# Rezoning Transportation Analysis

Petition Number: 2021-174

General Location Identifier: 20511225

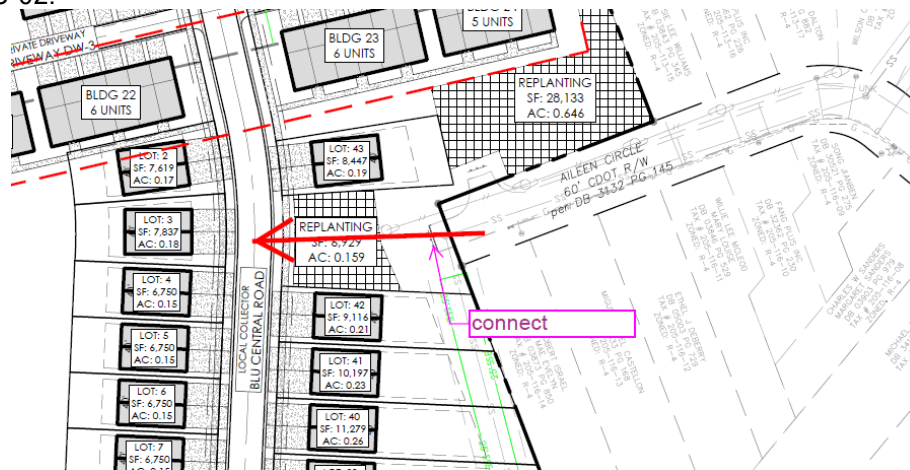
**Curblines:** The proposed zoning district has a setback measured from back of the future curblines.

- East Westinghouse Boulevard:** The future back of curb and gutter shall be installed at 33 feet from the existing street centerline. Revise site plan to show the future back of curb.

Label and dimension the existing and future curb and gutter from the centerline for each road on the site plan.
